The title "Development Application ACCESS REPORT" is displayed in a large, bold, black sans-serif font. The word "ACCESS" is significantly larger and bolder than the other words. The background of the page features a large blue diagonal shape on the left and a grey diagonal shape at the bottom, with a photograph of a wheelchair and a person's feet on a textured surface.

Reference Number: 25120

Site Address: 16-20 Middle Harbour Road, Lindfield
NSW

This Access Compliance Report is to accompany a Development Application (DA) for the development proposed at **16-20 Middle Harbour Road, Lindfield NSW**

Basement 3

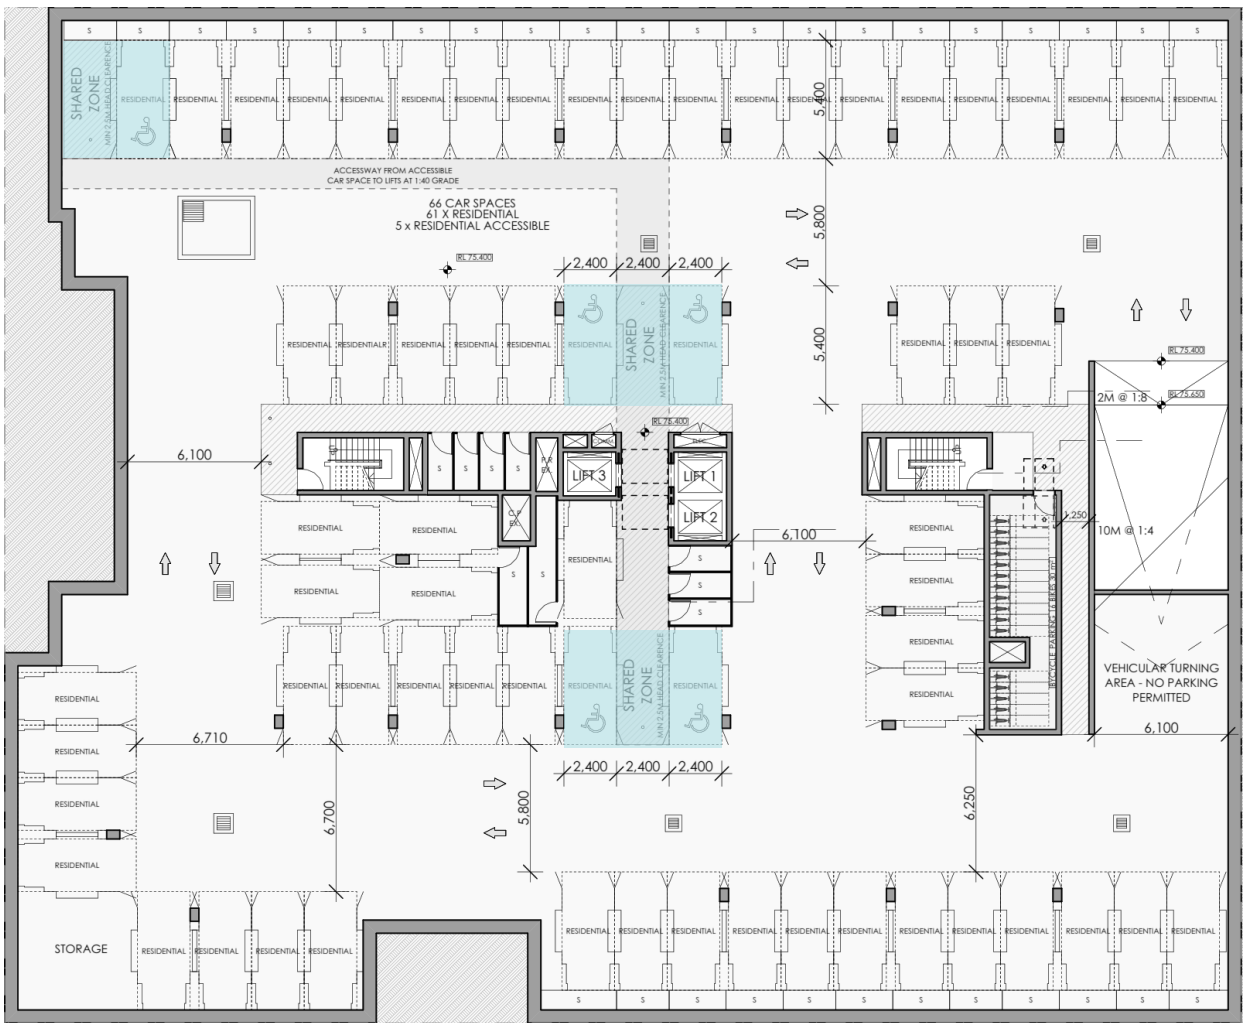
One accessible parking space is required to be allocated to each of the Platinum units.

Type B

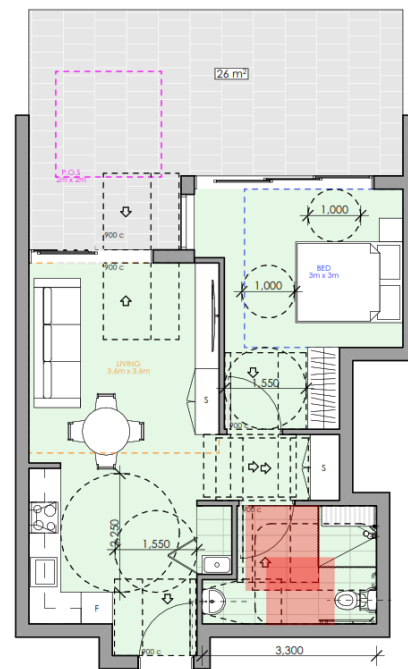
At CC stage, the 1200x1200 WC circulation and shower circulation to be shown and dimensioned in all platinum units. Shown in red below.
